**Overview:** The initial production release of the FTI-TLK1 harness has an issue where in some vehicles the secondary power input to the CN1 connector will overload the associated vehicle circuit, causing a fuse to blow. This issue affects the initial release of harnesses and is already being addressed in production. A field correction procedure is detailed below in Figure 1.

# FTI-TLK1 Type 3B3 - Vehicle Coverage & Preparation Notes

## FTI-TLK1 Type 3B3

**Figure 1: Step by step adapter correction**

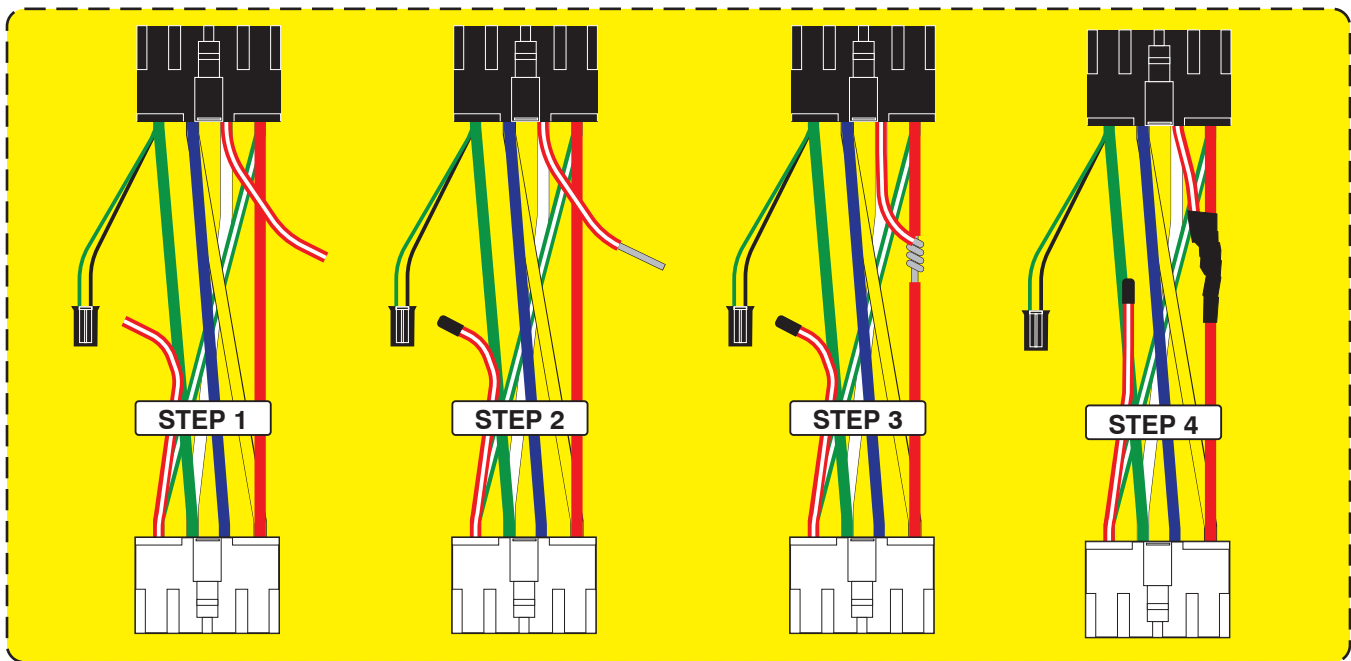
**Issue:** The secondary power circuit can overload some vehicle ignition switch circuits, causing a blown 5A/7.5A AM1 fuse, potentially disabling the vehicle and leaving the consumer stranded. Affected adapters are illustrated below in figure 2.

- 1.) Select the applicable CN1 adapter, isolate the RED/WHITE power wire, cut wire approximately 4" from the BLACK plug
- 2.) Insulate the wire still connected to the WHITE plug using heat shrink tubing, and strip the insulation on the other wire end
- 3.) Strip a portion of the insulation from the RED wire, attach the stripped RED/WHITE to the exposed RED wire, solder together
- 4.) Apply insulating tape to the soldered connection and secure the cut ends back to the bundle of wires created by the adapter
- 5.) Correction complete, you may safely proceed to finish your installation

**Figure 2: Supplied CN1 Harness Adapters**

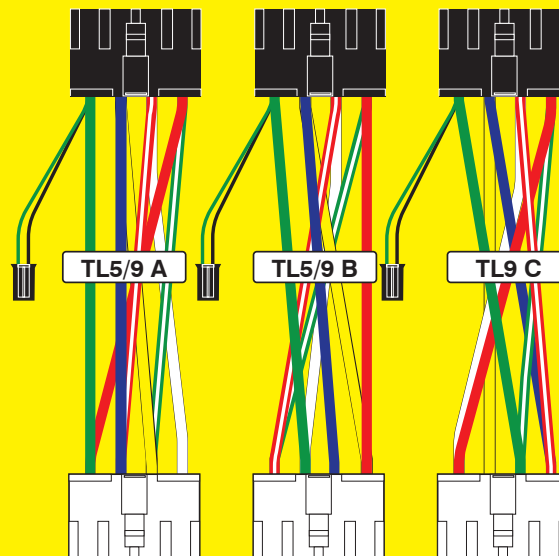
**Incorrect power provisions with the potential to overload vehicle ignition supply circuit, resulting in blown AM1 fuse.**
